**Proposed Rezoning From “AGR” & “GB” To “G/IC” for
a Proposed “Social Welfare Facilities” (Residential Care Homes for The Elderly) (RCHE)
Lot 232 RP, 232 S.A RP, 232 S.A ss. 1 to 14, 232 S.B RP, 232 S.B ss. 1 to 27,
232 S.C to 232 S.E, 233 RP, 233 S.A to 233 S.M, 237 RP, 237 S.A to 237 S.R,
239 RP, 239 S.A to 239 S.G in D.D.23, Tung Tsz, Tai Po, N.T.
S12A Application for Planning Application No. Y/NE-TK/19
Response-to-Comment – PlanD
(Updated 6 May 2025)**

Comments	Response
<p>1. Comments of the District Planning Officer/Shia Tin, Tai Po and North, Planning Department as follows:</p> <p>I refer to the subject application received on 17.1.2025 with the application form and the Supporting Planning Statement. Please find the comments from the district planning perspective below.</p> <p><i>Supporting Planning Statement</i></p> <p><u>General Comments</u></p> <p>1. The application site (the Site) with a site area of 1,494.67m² mainly falls within “Agriculture” (“AGR”) zone (about 98.6% of the Site) with a minor portion in “Green Belt” (“GB”) zone (about 1.4% of the Site) on the approved Ting Kok Outline Zoning Plan (OZP) No. S/NE TK/19. The applicant proposes rezoning the Site from “AG

FIGURE NO.

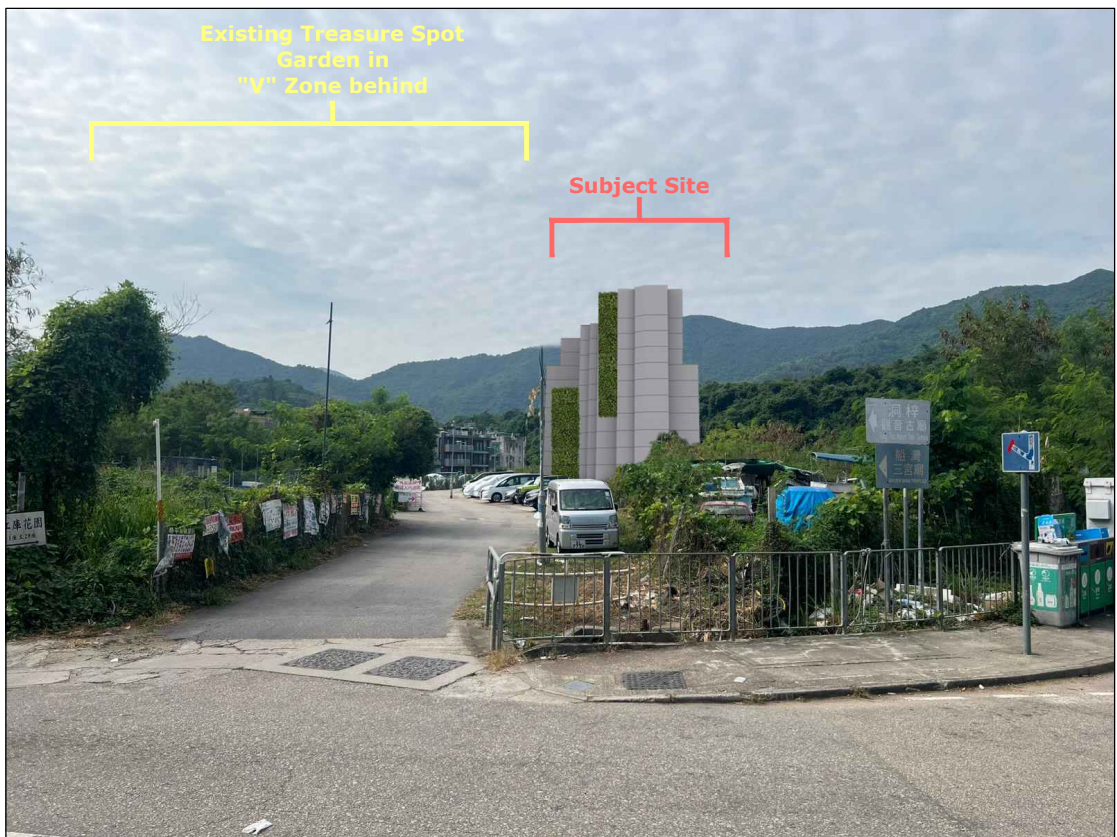
Comments	Response
<p>been obtained to ensure the future right of way to the Site.</p> <p>5. Section 2.1.1 – It is noted that Lot 238 in D.D. 23 is not included in the site boundary. As the proposed development will separate this private lot with the local track leading to Tung Tsz Road, please advise if right of way will be reserved for the owner(s) of this private lot, or suggest the alternative arrangement.</p> <p>6. Section 2.3 –Please provide more detailed explanation on the topographic restraints leading to difficulties in complying with Building (Planning) Regulations 41 regarding the required width of emergency vehicular access.</p> <p>7. Section 2.4 –Please advise whether there will be any shuttle bus services designated for serving the proposed RCHE. If yes, the details of the routing, operation hours and frequency of shuttle bus should be provided.</p> <p>8. Section 2.4 –Please confirm with Transport Department (TD) if the residents’ bus route No. NR532 (Tai Po Market Station ↔ Tung Tsz Villas) is genuinely open to general public. Also please advise the number of seats provided per residents’ bus.</p> <p>9. Section 2.4 –It is noted that there are minibus and bus routes in vicinity of the Site, please indicate the distances between the Site and the concerned minibus/bus stops on</p>	<p>R.O.W. would be provided to Lot 238 in D.D. 23.</p> <p>Fire safety enhancement would be proposed for substandard EVA during the FSD submission. ie. Fast-respond-type sprinkler head.</p> <p>Please be advised that shuttle bus services between the proposed RCHE and Tai Po Market Station will be provided, please refer to Section 2.6 of the revised TIA report for the routing, operation hours and frequency of shuttle bus.</p> <p>Please note that NR532 is open to general public. Please be advised that the number of seats provided per residents’ bus is 28 nos.</p> <p>The information could be found in the following website of the public domain: https://hkbus.fandom.com/wiki/%E5%B1%85%E6%B0%91%E5%B7%B4%E5%A3%ABNR532%E7%B7%9A</p> <p>Revised accordingly.</p>

Comments	Response
<p>Figure 5.</p> <p>10. Section 2.4 –The concerned minibus/bus stops are not located very close to the Site, while the future residents/visitors of the proposed RCHE will be required to walk to the Site from the concerned minibus/bus stops. It is noted that there is no proper footpath adjoining the Site, please advise how to ensure pedestrian/road safety of the future residents/visitors of the proposed RCHE (in particular elderly).</p> <p>- According to the further information received on 17.3.2025, for Figure 4 in the responses to comments of the Social Welfare Department, please advise whether the footpaths indicated on the figure are referring to the existing informal footpaths or the footpaths proposed to be provided by the applicant. If they are referring to the footpaths proposed to be provided by the applicant, please advise (i) whether the consent(s) have been obtained from relevant owner(s) of any private lots and/or the Lands Department with respect to any Government land and (ii) the maintenance and management arrangements of the proposed footpaths. Nevertheless, it is noted that the widths of footpath varies from Tung Tsz Road to the Site, in which some parts are very narrow and could not be considered as proper access. Please review Figure 4 and indicate the widths of footpaths.</p>	<p>(i) The proposed access road would not pass through any private lots but Government Land refer to Figure 4. Consent would be applied to relevant Government Department.</p> <p>(ii) Footpath and it's width are indicate on Figure 4.</p>
